City of Dilworth
Dilworth Community Center
Dilworth, MN

Project No. 25-011

ADDENDUM A

FOOTING & FOUNDATION PLAN

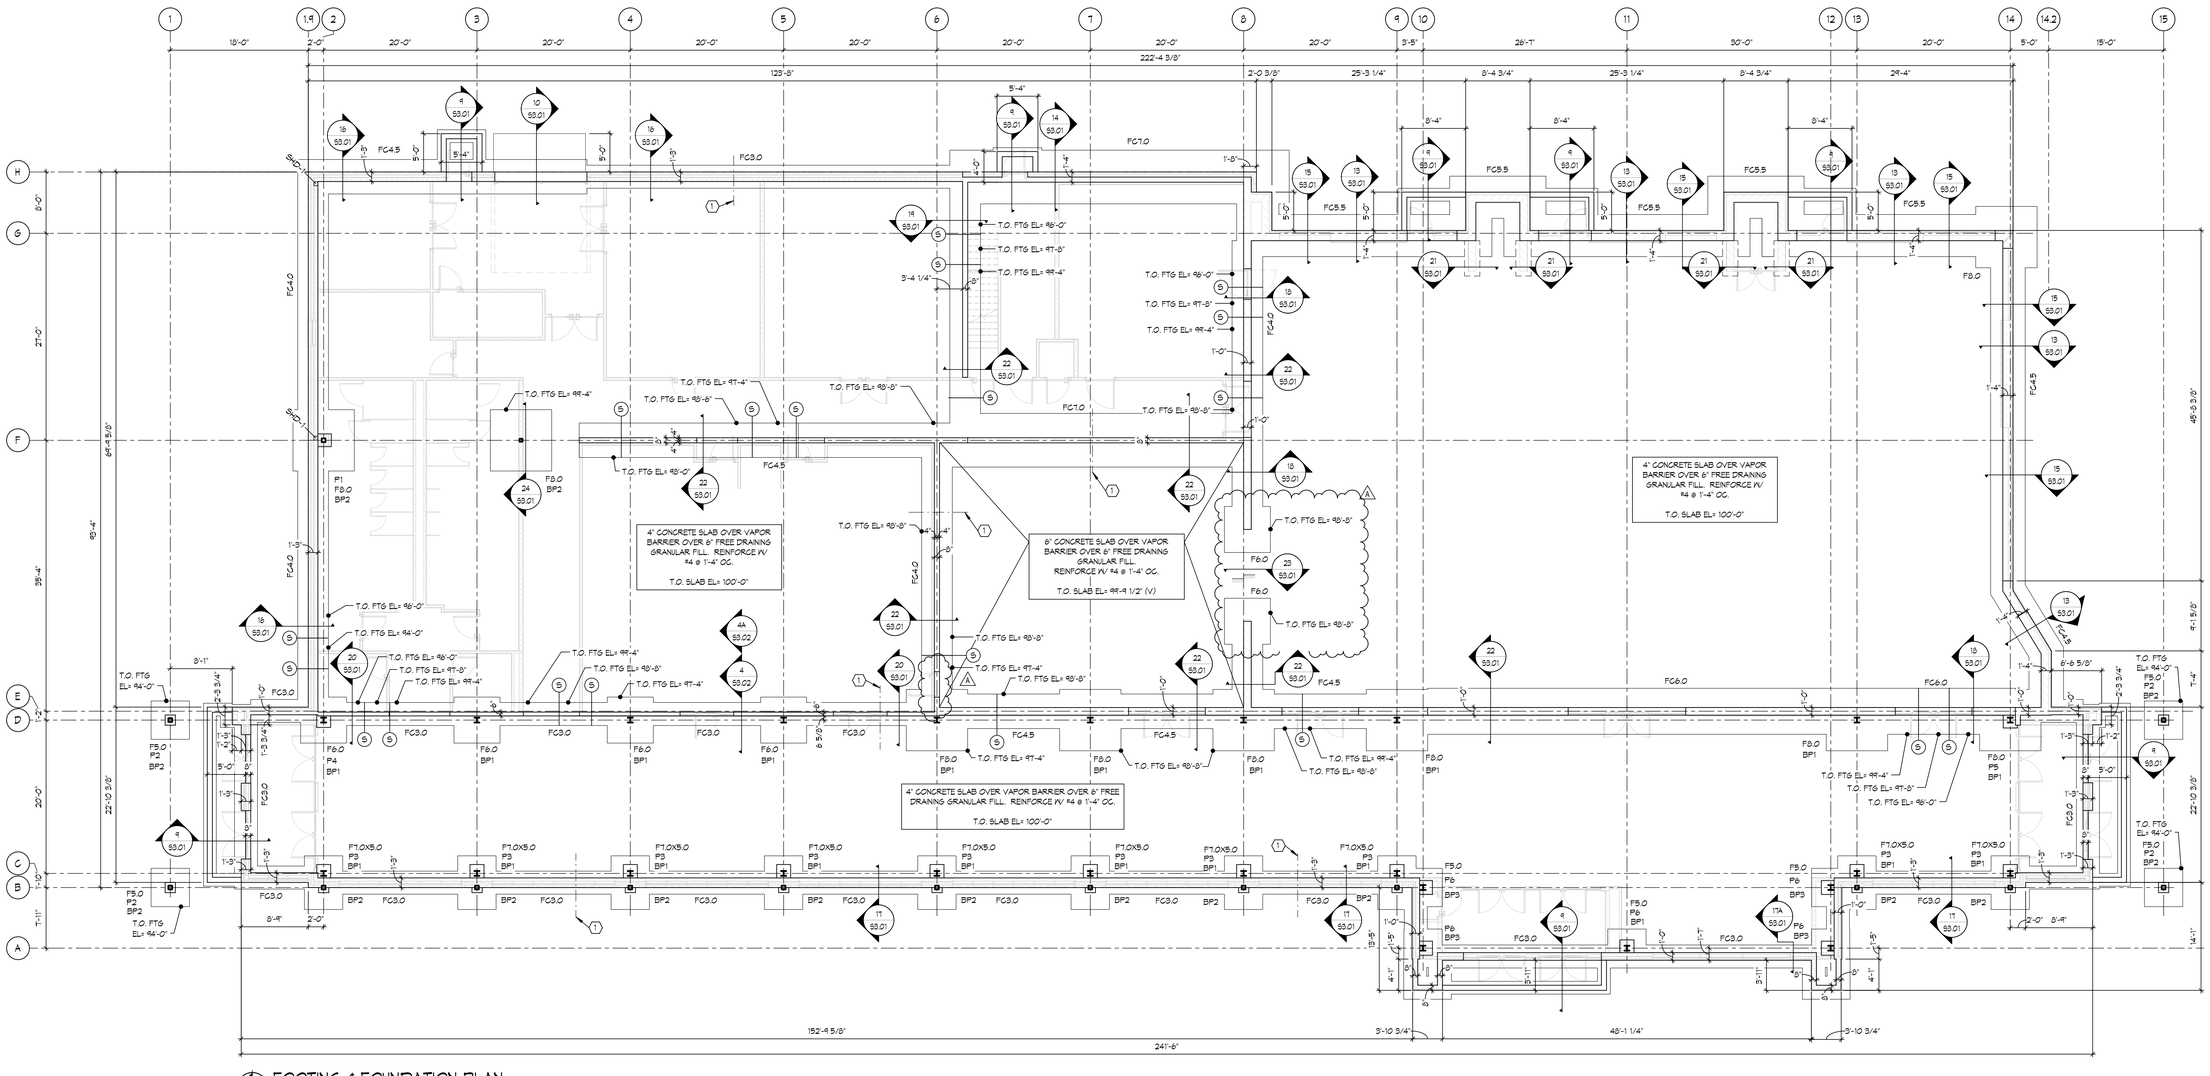
M. S1.01 Footing and Framing Plan – **Included in this addendum**
    a. Reflect changes associated with adding door 103.3

LOW ROOF FRAMING PLAN
1/8" = 1'-0"
JOIST BEARING EL= 114'-0" (UON)

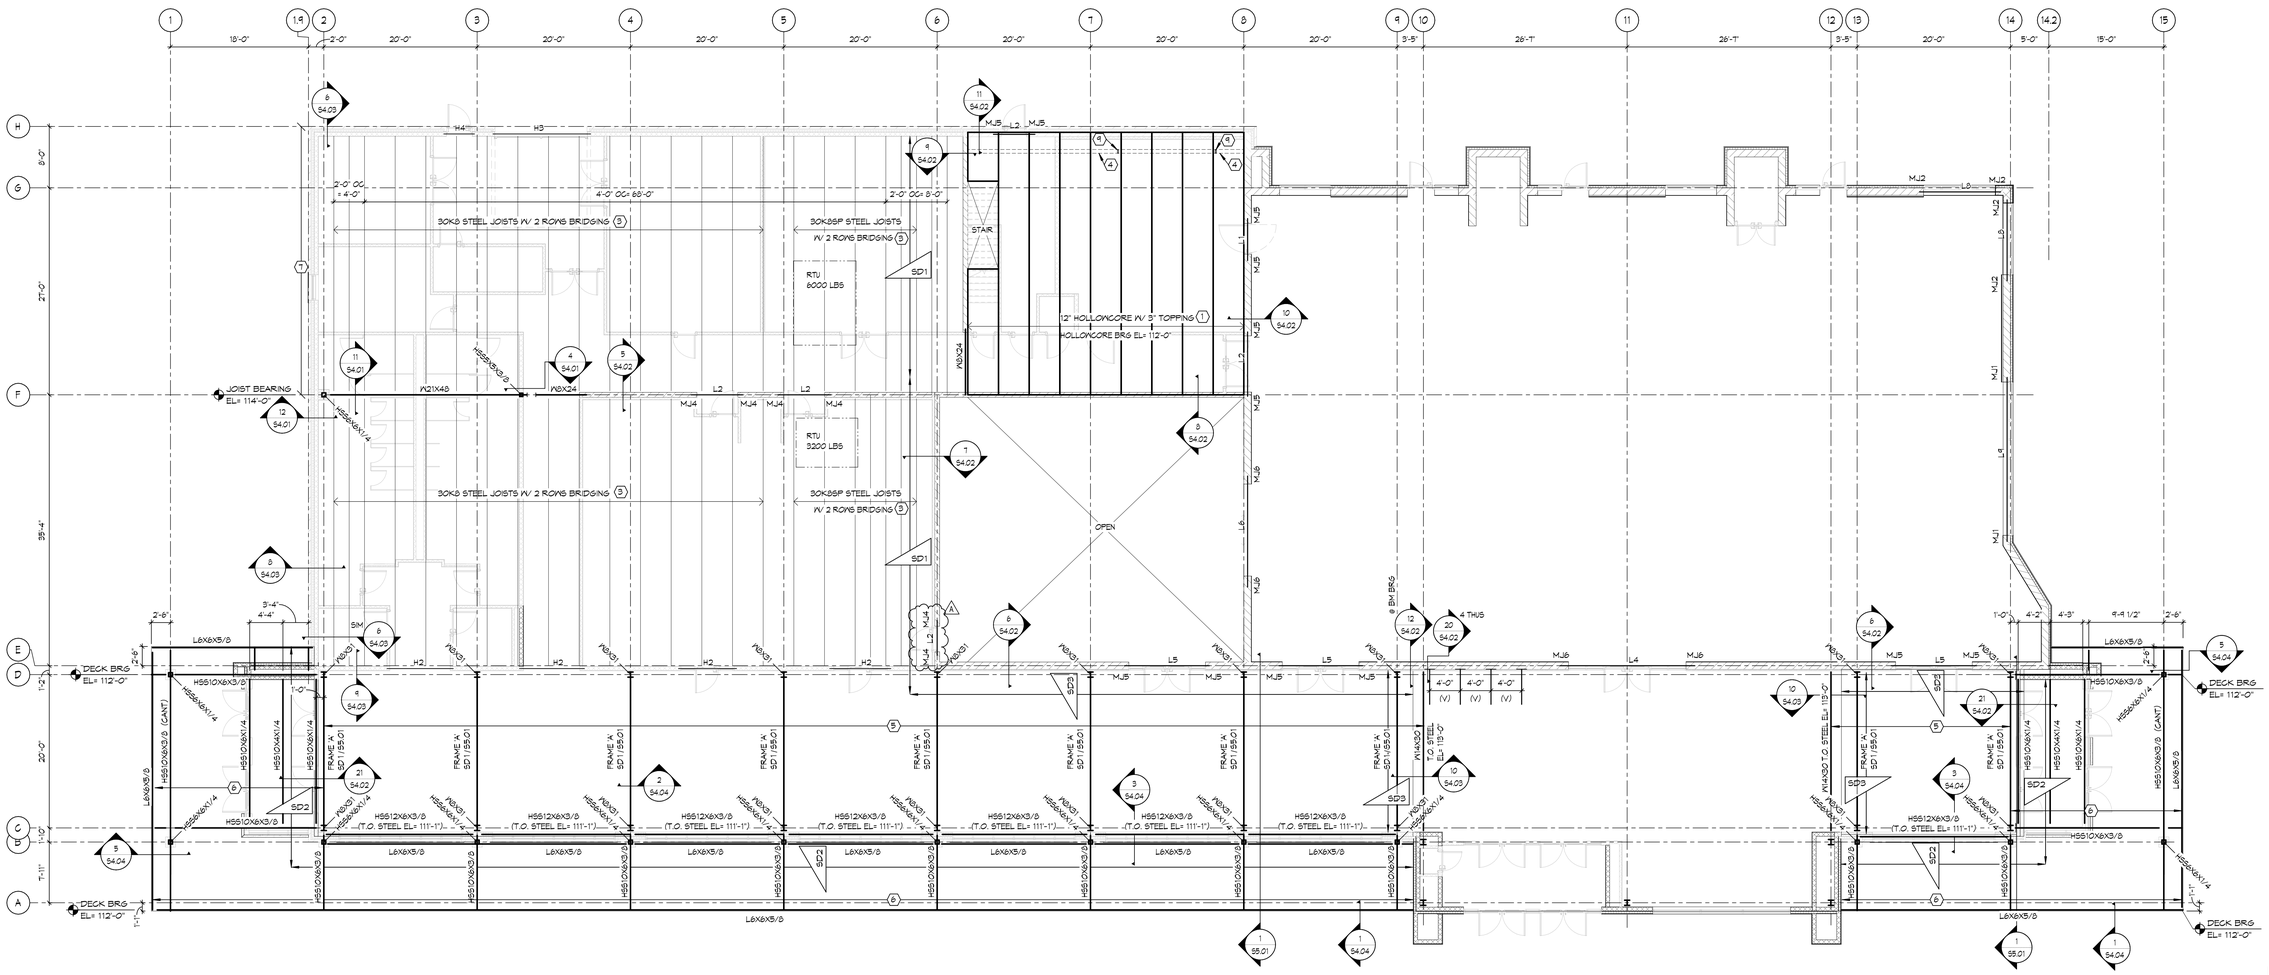
N. S1.02 Low Roof/Mechanical Mezzanine Framing Plan – **Included in this addendum**
    a. Reflect changes associated with adding door 103.3

NORTH 1 MAIN LEVEL - SYSTEMS
SCALE: 1/8" = 1'-0"

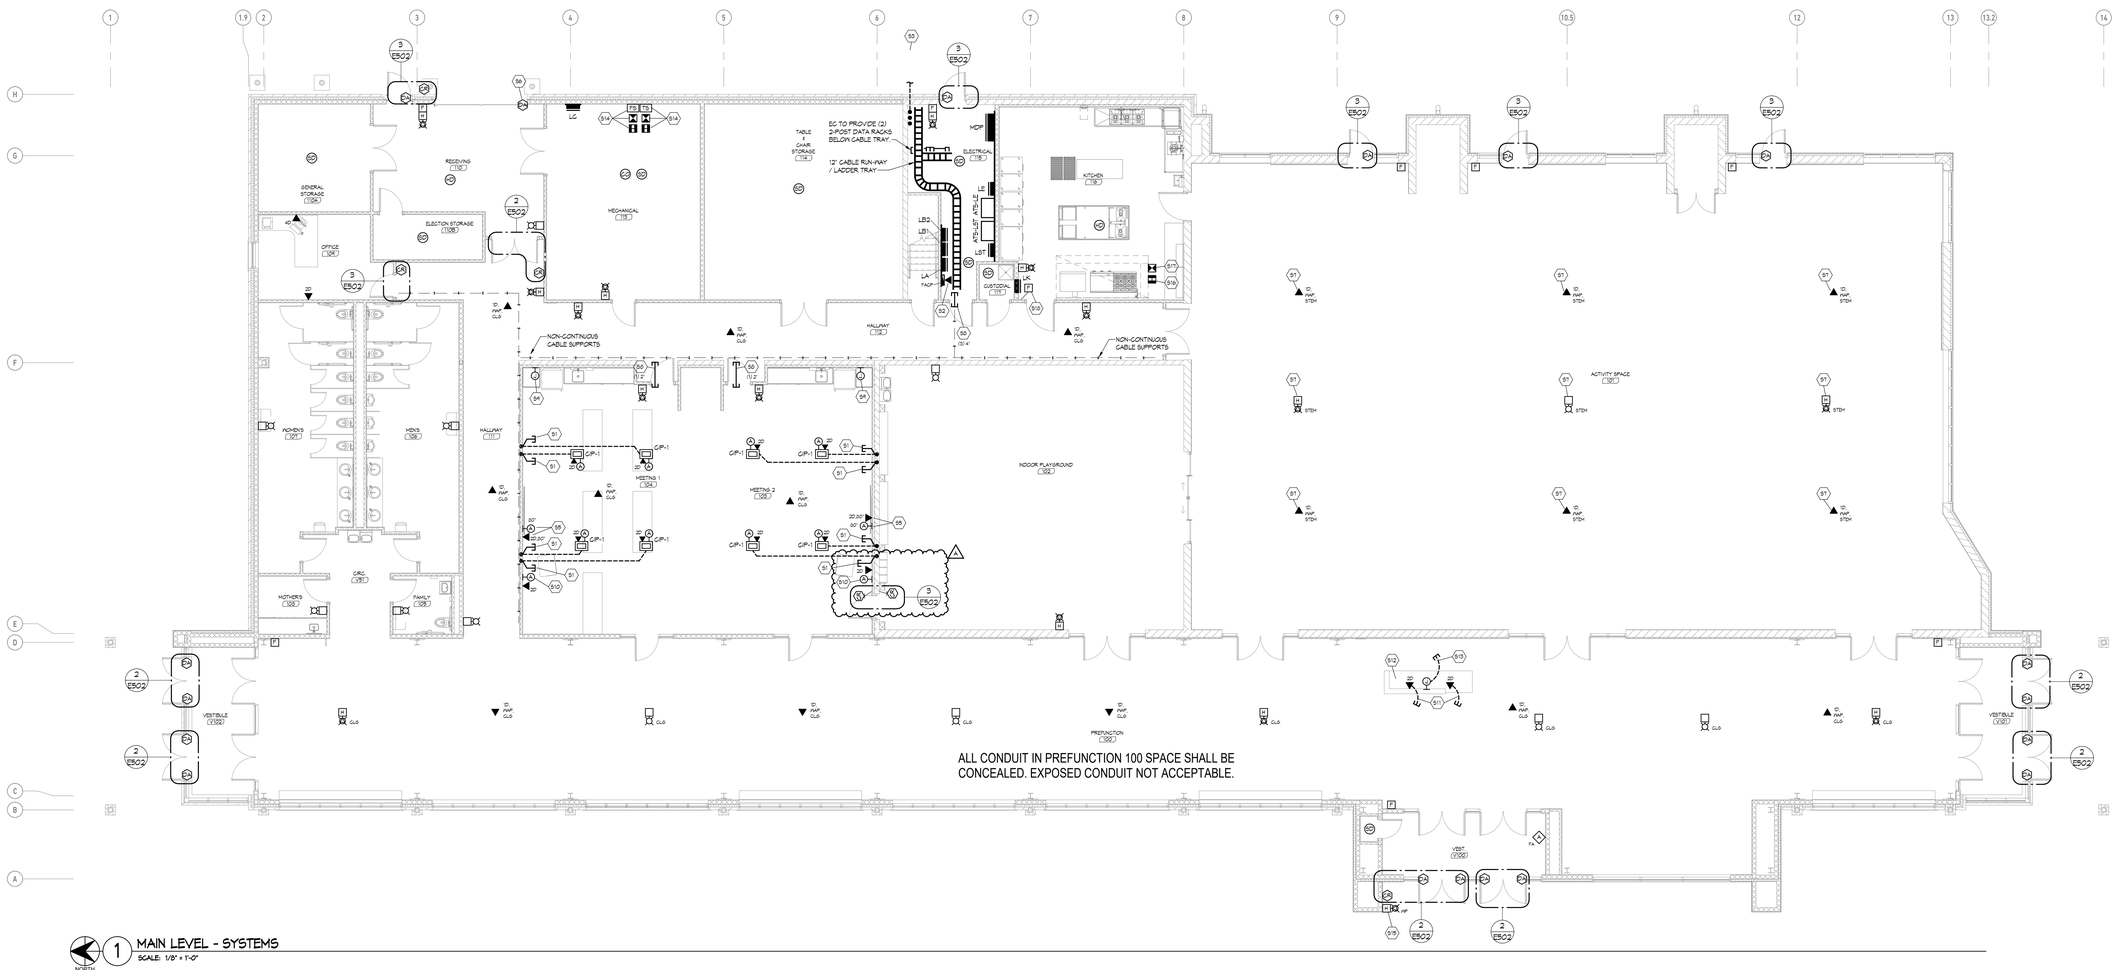
A. Detail 1:
   1. Meeting 2 103:
      a. Provide card reader at new door into Indoor Playground, callout 3/E502.
      b. Revise location of data and AV locations.
      c. Provide data tag 2D at data jack.
   2. Indoor Playground 102: Provide card reader at new door into Meeting 2, callout 3/E502.
